October 9, 2025

TO LABORATORIES AND MANUFACTURERS PARTICIPATING IN THE SEI/ASTM VERIFICATION PROGRAM FOR BALLISTIC SHIELDS TO ASTM E3347:

The purpose of this Bulletin is to provide clarification on several points related to ballistic shield testing to ASTM E3347.

Figure 1 would also be revised to include “Y” as shown below.

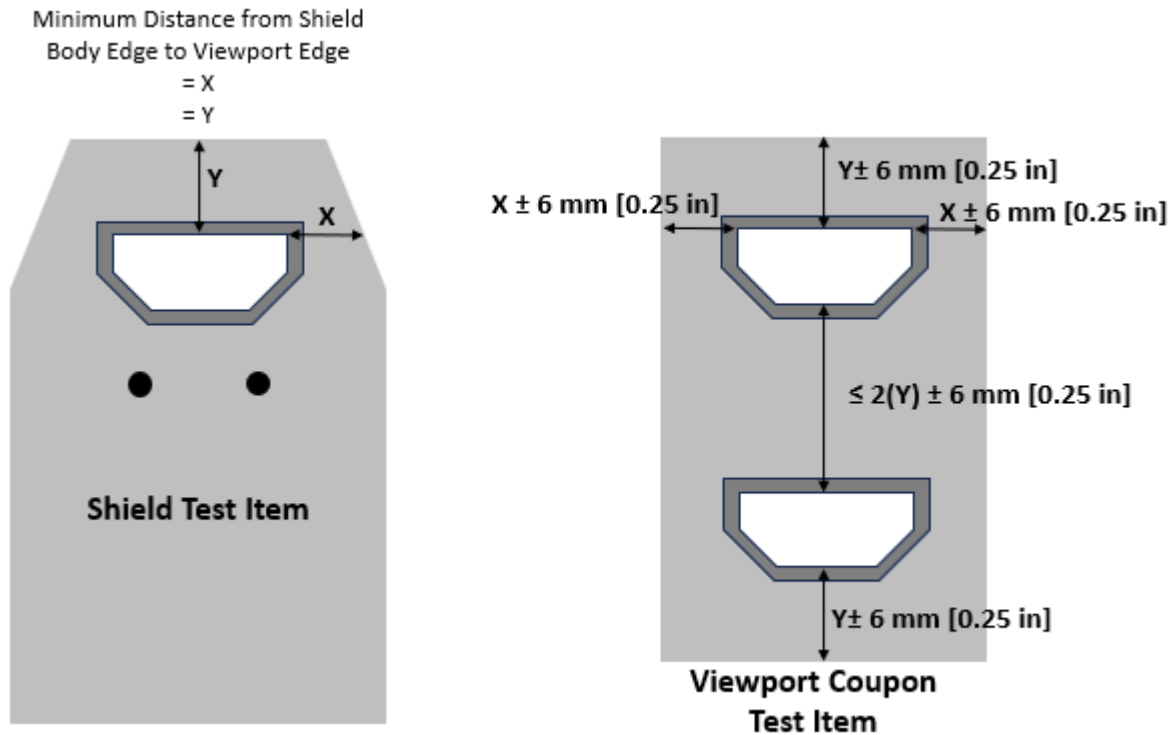
It has come to our attention that when applied to viewports which are not rectangular, the measurement identified in 4.1.1.2 and Figure 1 is ambiguous and may result in viewport coupons of odd shapes which do not represent actual shield construction.

As a result, SEI is suggesting that the following language be added to the next standard revision:

4.1.1.2 For a viewport coupon, the minimum horizontal and vertical distances from the viewport edge to the coupon edge shall be the minimum horizontal and vertical distances as measured on an actual shield, as described in 4.1.1.2.1 and 4.1.1.2.2, ± 6.0 mm (0.25 in.).

4.1.1.2.1 A measurement, labelled “X” in Figure 1, shall be taken on an actual shield to determine the minimum horizontal distance from the point on the viewport edge nearest the shield’s side edge.

4.1.1.2.2 A measurement, labelled “Y” in Figure 1, shall be taken on the actual shield to determine the minimum vertical distance from the point on the viewport edge nearest the shield’s top edge.

4.1.1.3 The viewport coupon may contain one or more viewports. If the viewport coupon contains multiple viewports, the distance between adjacent viewport edges shall be no more than twice the distance

listed in 4.1.1.2.2. See Fig. 1 for a graphical representation of the distance requirements for viewport coupons.
